SUBJECT: Duke Power Company LLC d/b/a Duke Energy Carolinas, LLC
(Duke)
Oconee Nuclear Station, Units 1, 2, & 3
Docket Numbers 50-269, -270, -287
Relief Request 06-ON-004 Request for Additional Information

OCONEE NUCLEAR STATION
Response To
Second Request for Additional Information
Request for Relief No. 06-ON-004
Pressurizer Alloy 600 Weld Overlays
(TAC No. MD2887)

Figure 1 Phased array sector scan of hot leg surge line nozzle. Incomplete coverage illustrated by hatched area in nozzle. Incomplete coverage not illustrated on austenitic end. Dimensions are typical.

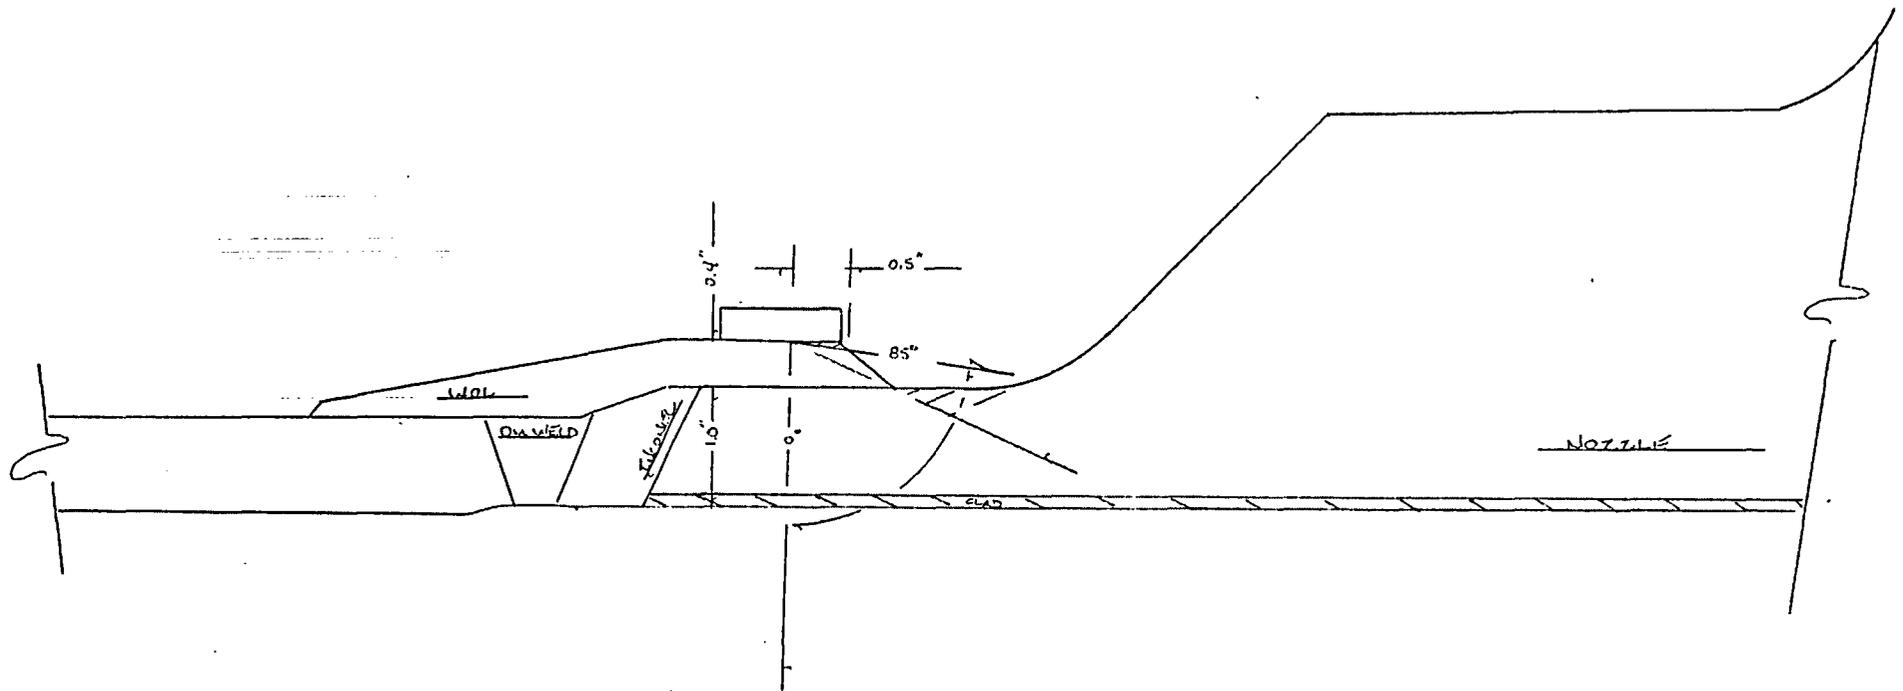
Identify the UT acceptance criteria that will be used for the complete full structural weld overlay and heat affected zone beneath the weld overlay. If the acceptance criteria to be used is not consistent with the respective positions stated in Regulatory Guide 1.147, Rev. 14, for the applicable code cases, provide the technical bases for its use.

Approval of Code Case N-638-1 stated in Regulatory Guide 1.147, Rev. 14 imposes a condition that the ultrasonic examination be qualified on samples using construction type flaws and that the acceptance criteria be in accordance with NB-5330 of Section III of the ASME Boiler and Pressure Vessel Code. In lieu of this requirement, Duke proposes to use an EPRI Performance Demonstration Initiative (PDI) qualified ultrasonic examination procedure that is designed and qualified to examine the entire volume of the overlay weld as well as the region of the P1 material containing the weld heat affected zone (HAZ) and a volume of unaffected base material beyond the HAZ (see Figures 1, 2 3 and 4)
